**CITY OF OAKLAND
COUNCIL AGENDA REPORT**

TO: Office of the City Manager
ATTN: Deborah Edgerly
FROM: Community & Economic Development Agency
DATE: May 4, 2004
RE: A PUBLIC HEARING AND RESOLUTION DENYING THE APPEAL AND SUSTAINING THE DECISION OF THE PLANNING COMMISSION IN APPROVING TENTATIVE TRACT MAP TTM7485, TO RE-SUBDIVIDE TWO EXISTING PARCELS INTO FIVE PARCELS (A04-110, EAST SIDE OF CRESTMONT DRIVE AT THE INTERSECTION WITH WESTFIELD WAY, APN'S: 37A-3148-040 AND 37A-3148-041).

RESOLUTION DENYING THE APPEAL AND SUSTAINING THE DECISION OF THE CITY PLANNING COMMISSION IN APPROVING TENTATIVE TRACT MAP TTM7485, TO RE-SUBDIVIDE TWO EXISTING PARCELS INTO FIVE PARCELS (EAST SIDE OF CRESTMONT DRIVE AT THE INTERSECTION WITH WESTFIELD WAY, APN'S: 37A-3148-040 AND 37A-3148-041).

TENTATIVE TRACT 7485
SITE PLAN

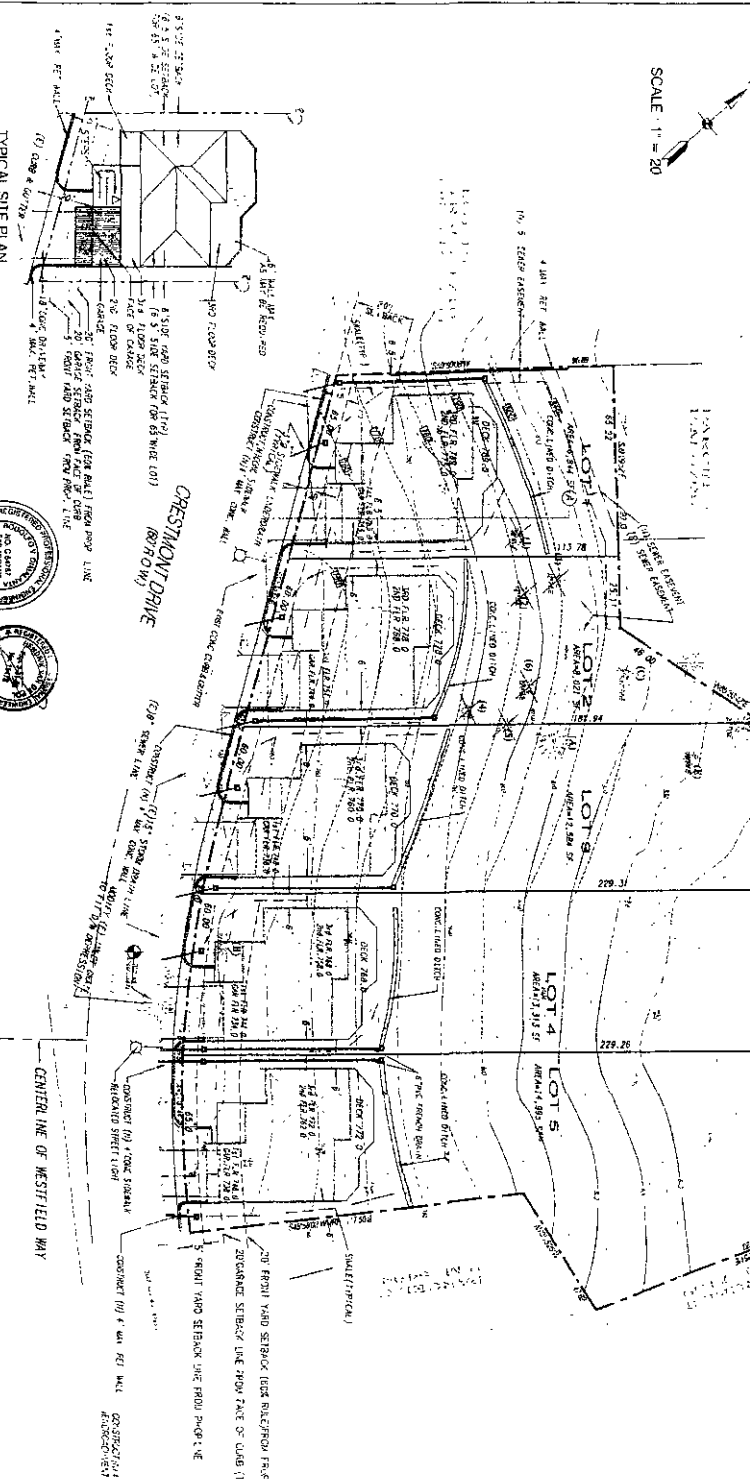
- FM 2) Provide documents showing the width, purpose and how the (E) easement was created. The map shows proposed structure on Lot 2 is on top of the (E) easement.

- FM 3) Is the new easement an alternate easement if the plan is to abandon the (E) easement? Proposed sewer easement shows width as 5'. The City of Oakland requirement for new easement is 10'.

- BP 4) Provide detailed plan for concrete lined ditch.
- BP 5) Submit hydrology calculations as well erosion and sedimentation control measures. Measures shall be Peer-reviewed by City approved Consultant.

- BP 6) Minimum sidewalk width is 5' unobstructed and the standard slope is 1/4" per foot. Revise sidewalk width shown on the Typical Section of the map to 5'.

- FM 8) All improvements must be inside property line.
- BP 9) Show plan and profile of proposed sanitary and storm sewers and other public utilities with grades and sizes indicated.

- FM 10) Also include in the tentative map the name of Tract or Grant in which subdivision is located.
- FM 11) Provide preferably computer generated closure calculations for each lot.

FM (12) IMPROVEMENT BONDS SHALL INCLUDE MASS GRADING

ANDY: I have reviewed the map with the above conditions indicated FM shall be required when filing the Final Map. Items marked BP shall be accomplished at time of Building Permit submission.
